Amendments to the Drawings:

REMARKS

Claims 1 to 47 are pending.

Fig. 4

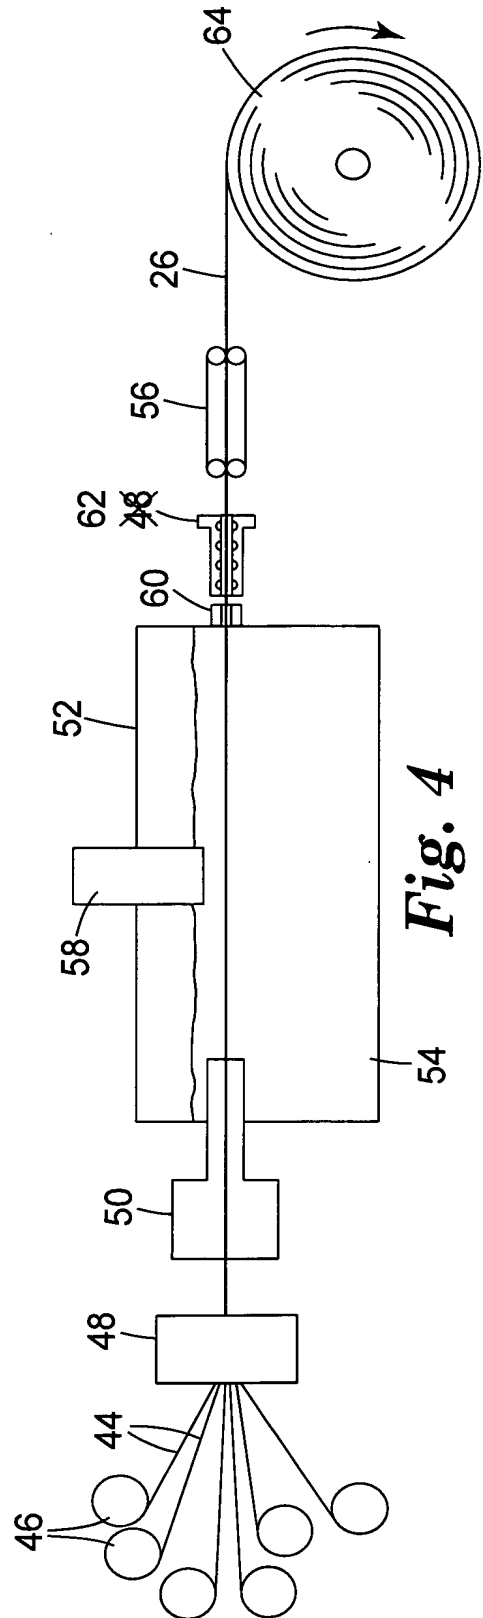
The drawings are objected to as failing to comply with 37 CFR 1.84(p)(4) because it is said reference character “48” in Figure 4 has been used to designate both the tube furnace and what appears to be the stream of gas or liquid described on page 15, line 21 of the specification and designated as reference number 62. Corrected drawing sheets in compliance with 37 CFR 1.121(d) are said to be required in reply to the Office action to avoid abandonment of the application. Further, it is said any amended replacement drawing sheet should include all of the figures appearing on the immediate prior version of the sheet, even if only one figure is being amended. Each drawing sheet submitted after the filing date of an application must be labeled in the top margin as either “Replacement Sheet” or “New Sheet” pursuant to 37 CFR 1.121(d). If the changes are not accepted by the examiner, the applicant will be notified and informed of any required corrective action in the next Office action. The objection to the drawings will not be held in abeyance.

FIG. 4 has been corrected to replace one of the reference numbers "48" with 62. Support for this amendment can be found in the specification, for example, on page 13, lines 13-24 and page 15, lines 20-24.

FIG. 4 has been amended to correct the dual use of reference number 48. Further, page 15 (and page 13) has been amended to more clearly discuss reference number 62.
